DEVIATION REQUEST AND DECISION FORM

Project Name : Trails at Aspen Ridge Filing No. 2
Schedule No.(s) : 5500000412
Legal Description : Unplatted Land

FILING NO. 2
ROADWAY & STORM IMPROVEMENT PLANS

ROADWAY PLAN & PROFILE

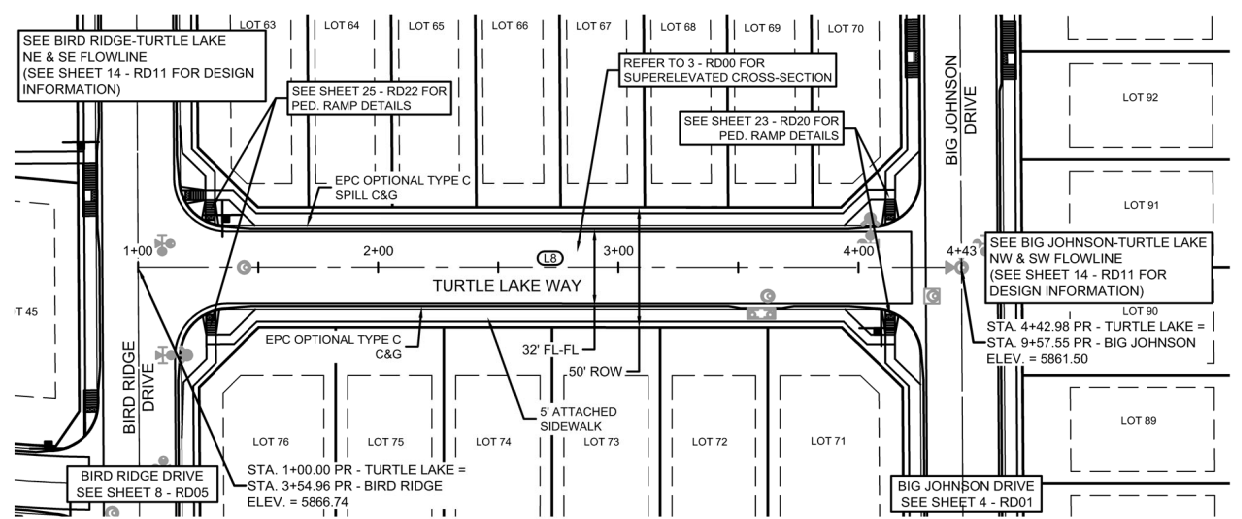
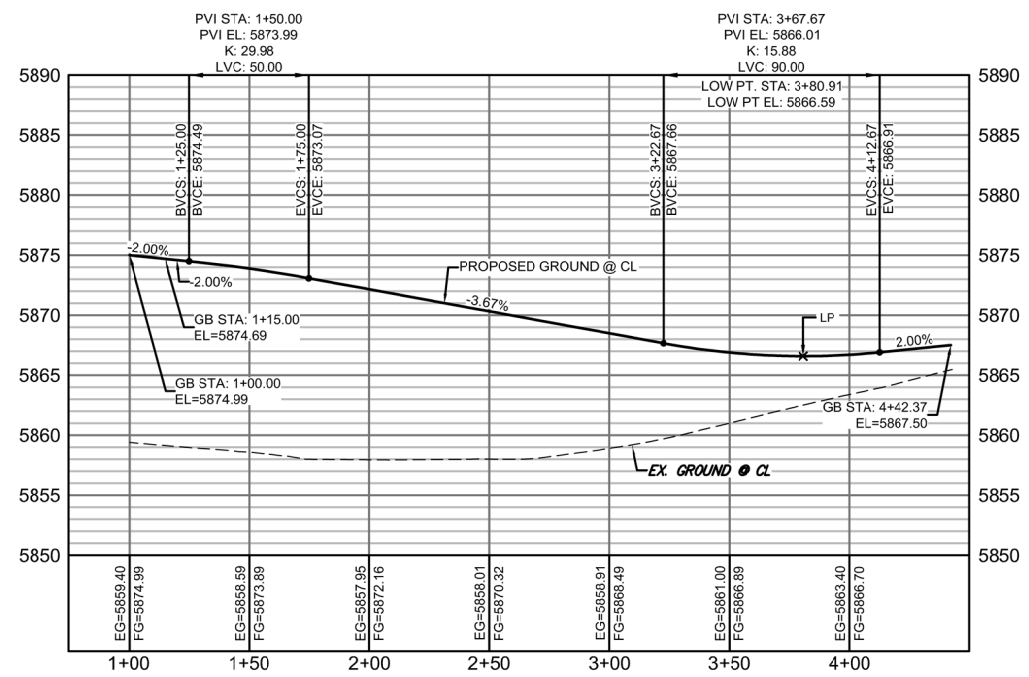
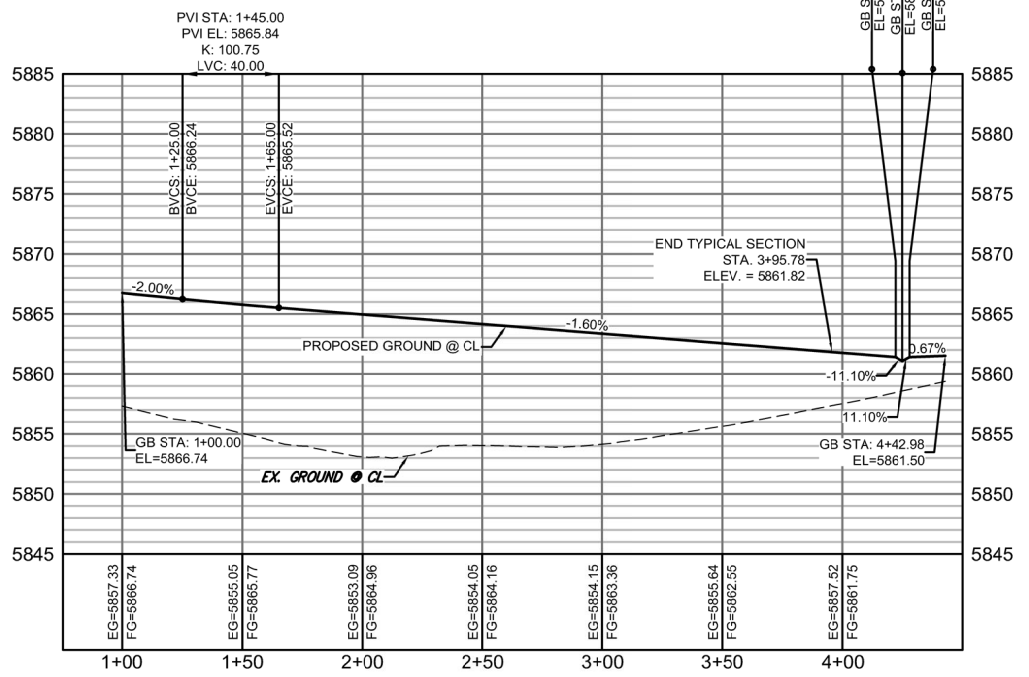
Per Section 2.3.3.D.2 "Superelevation is not permitted on roadways with design speeds of less than 50 mph"

Transitioning from warped intersections on the west and east ends to a typical, crowned section on Nutterbutter Point and Turtle Lake Way is impractical due to the short lengths of these roads.

In order to return to a crowned intersection and not superelevate the roadways of Turtle Lake Way and Nutterbutter Point, the rate of transition of grade would exceed comfortable and safe driving conditions. To mitigate this problem, the roads previously listed have maintained a superelevated cross section ranging from 2% to 5%.

In order to meet the intersecting roads of Big Johnson and Bird Ridge (4%-5%), the east and west ends of Turtle Lake Way and Nutterbutter Point have been warped. Using a transition of 1% in 25', it is impossible to get back to a typical crowned section for either road due to the shortness of length. Maintaining a superelevated section allows for comfortable and safe driving conditions.

This request has been determined to have met the criteria for approval. A deviation from Section 2.3.4 of the ECM is hereby granted based on the justification provided.

Approval of this deviation does not constitute approval of the configuration of the pedestrian ramps as shown on the exhibit.
